Point-by-point response to the second referee (Colin Gurganus)

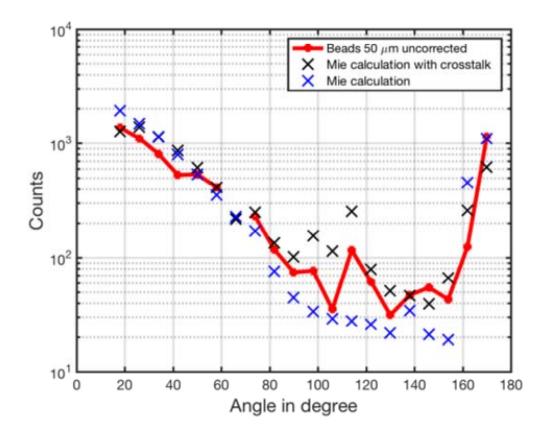
RC: I would like reasonable justification that channel crosstalk can explain the phase function discrepancy. This could be accomplished by covering some of the collection optics (ever other channel, or all channels except those with large deviation) and repeating the glass bead tests. If crosstalk is the explanation than you should see better agreement with the theoretical MIE curve with this simple test.

AC: A similar laboratory test as suggested by the Referee was performed (please see our answer to the "crosstalk correction" above). In addition, the laboratory deduced crosstalk was applied to the theoretical Mie curve of the 50 µm glass beads (Fig. below). This figure shows that (a) the crosstalk related features in the side and backscattering range of the raw scattering function can indeed be reproduced and (b) there are additional correction factors that stem from the differences in the detector field of view and the fiber transmissions that makes a correction solely based on the laboratory deduced crosstalk impossible.
